| Title - Sujet Toad River Maint. Camp Remediation | |
| Solicitation No. - N° de l'invitation EZ113-171201/A | Amendment No. - N° modif. 003 |

This Amendment 003 is raised to:

Extension of Time for Tenderers
Toad River Maintenance Camp Remediation
Toad River Maintenance Camp, km 648.7, Alaska Highway, BC
Solicitation No: EZ113-171201/A

TITLE: **GROUNDWATER DEPTH (AUGUST 17, 2014)**

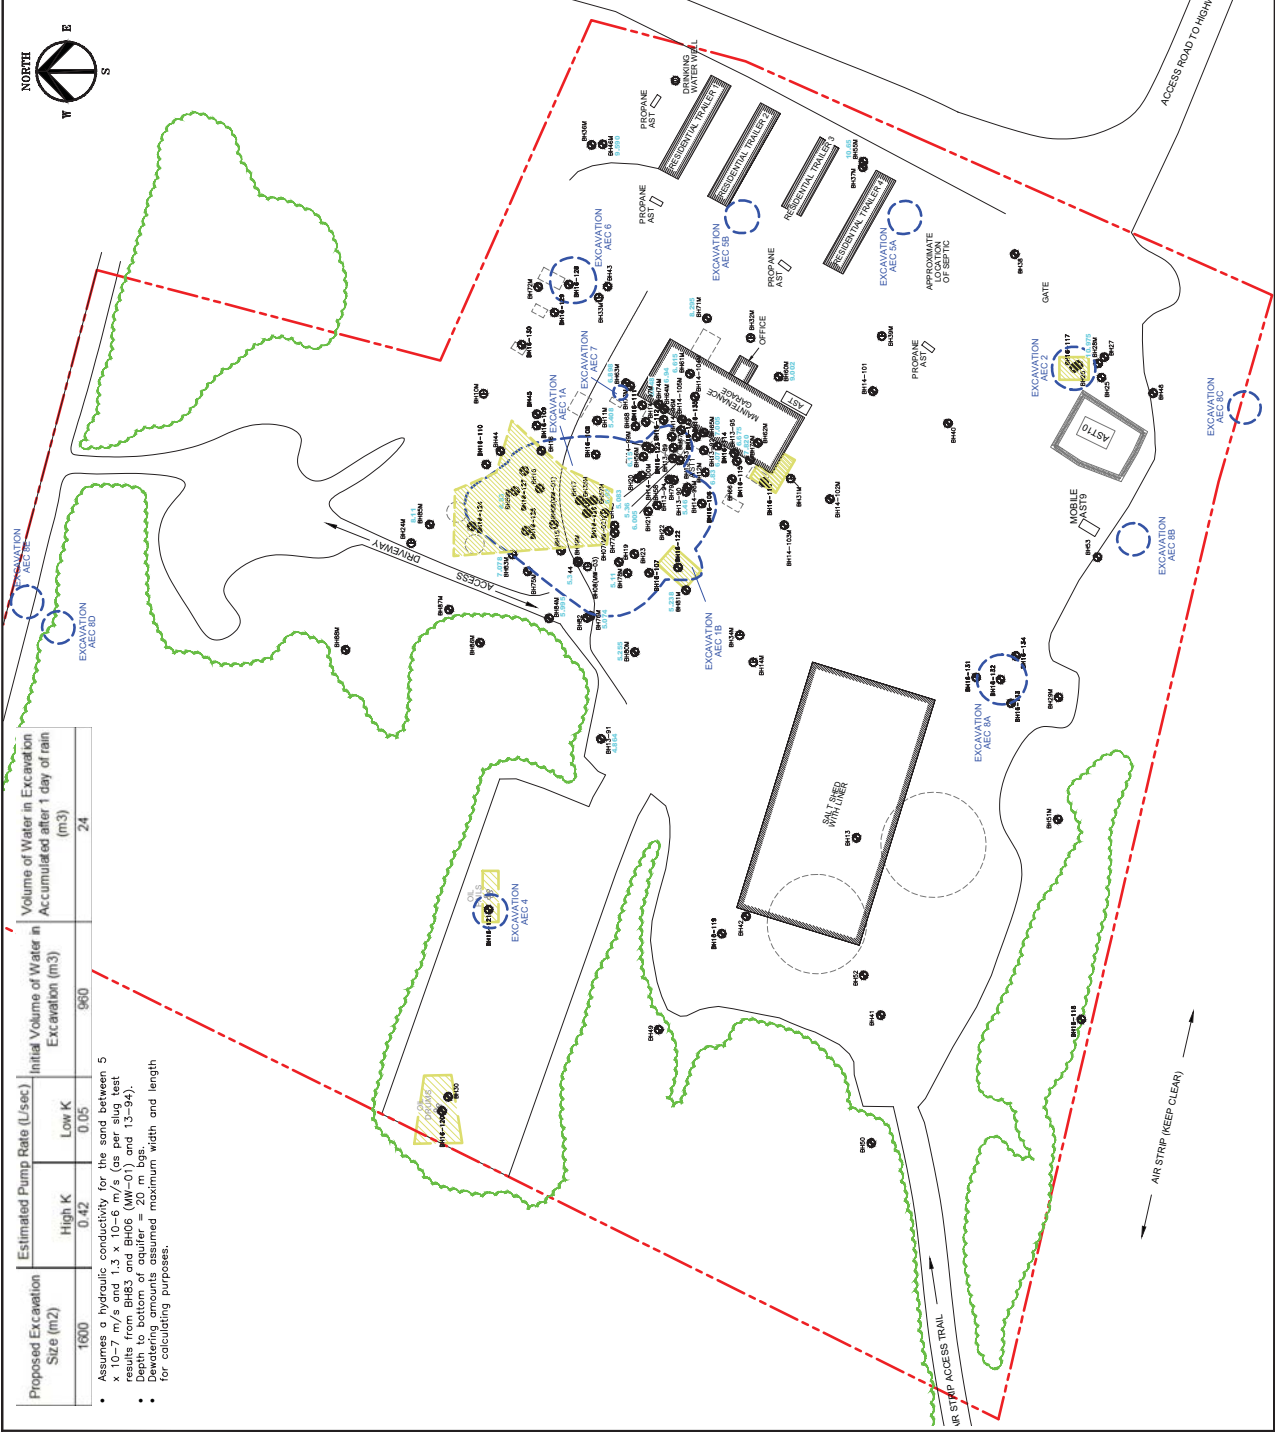
Drawings revised for elimination of excavation AEC 1C from scope.

3. Drawing 635734-304

Replace with attached Drawing 635734-304
